**PB# 85-70**

**Mannoni & Caiazzo**

TOWN OF NEW WINDSOR  
PLANNING BOARD  
REVIEW COMMENTS

PROJECT NAME: Mannoni and Caiazzo Subdivision  
PROJECT LOCATION: Route 207 near Beattie Road  
NW #: 85-70  
11 March 1987

ENTRANCE DETAILS

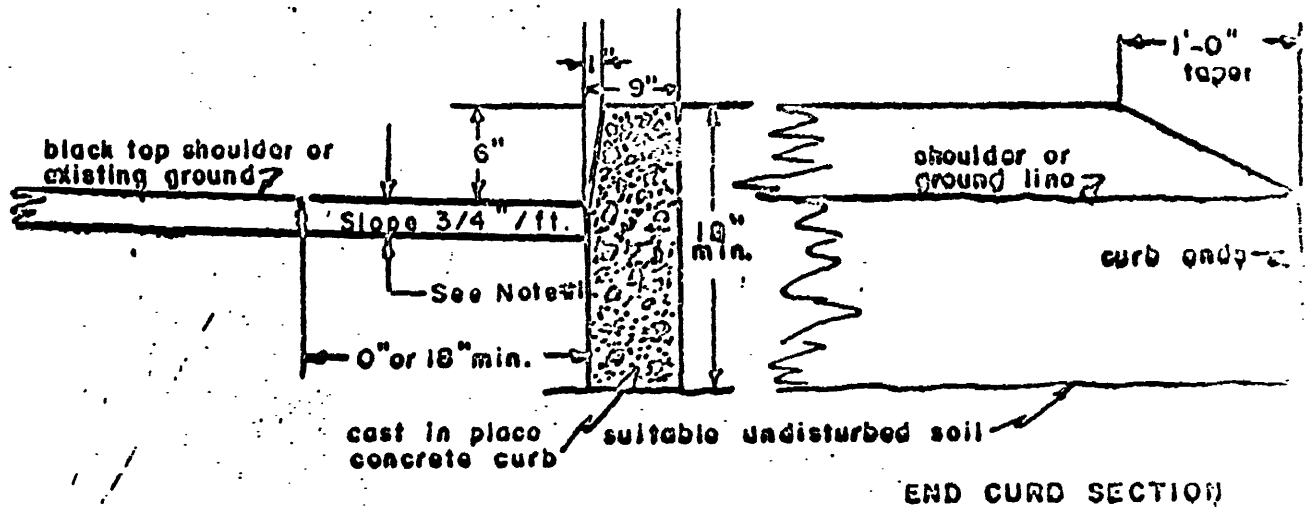
We approve of the driveway location, as proposed on the site plan. We recommend a 24+- foot width delineated with our standard 6 inch reveal concrete curbing, 25 foot radii, with 10 foot curb extensions along Route 207. Also, a 10-foot paved shoulder section will be required. Our standard details for curbing and pavement details must be shown on the final plan. Enclosed is a copy of the entrance and curbing details. We also recommend that the driveway geometry be shown on a bigger scale (preferably a 20 scale 1 inch = 20 feet) as the 1 inch to 100 foot is unacceptable.

- Shoulders paving - 3" Asp. Conc. on 8" of gravel.  
Driveway paving - 3" Base,  $\frac{1}{2}$ " Binder, 1" top, ( $\frac{5}{2}$ " Total) on 8" of gravel
- Provide contraction joints in curbing at approximately 15' intervals.
- Place suitable fill behind curb & top soil & seed or pave (2" or more)
